# Modification Recommended Service Note

## N9020B MXA Signal Analyzer

### Password for Instrument Account Expires After 42 Days

Figure 1. Computer Management Dialog

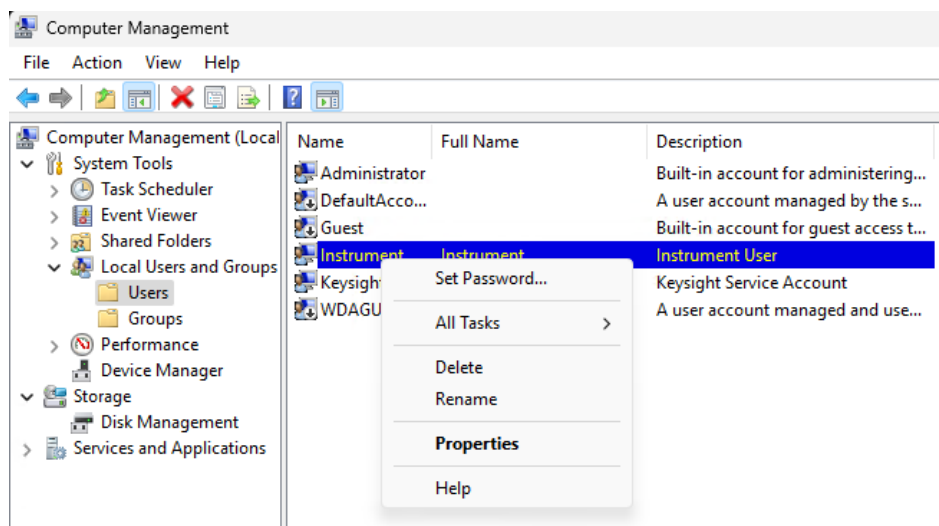
1. Connect a USB keyboard and USB mouse to two of the front-panel USB connectors
2. Log in as Administrator (default password: Keysight4u!)
3. Right-click on Windows icon and select Computer Management
4. Open System Tools, Local Users and Groups
5. Select Users
6. Right-click on Instrument and select Properties. See Figure 1 below.

Figure 2. Instrument Properties Dialog

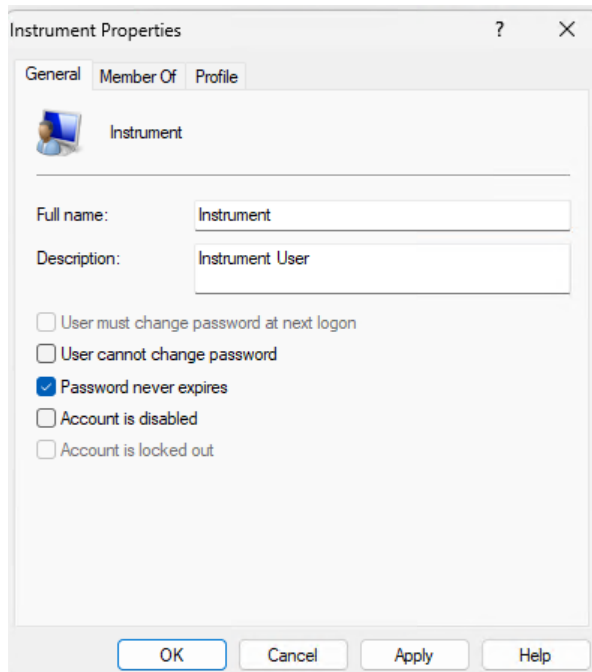
7. In the Instrument Properties dialog box, uncheck “User must change password at next logon”.
8. In the Instrument Properties dialog box, check “Password never expires”. See Figure 2 below.

9. Click “Apply” and “OK”.
10. Close the Computer Management dialog.
11. Cycle power on the analyzer.
12. Confirm that the analyzer boots up directly into the Instrument account, without any prompts to change the password, and automatically launches the XSA application.
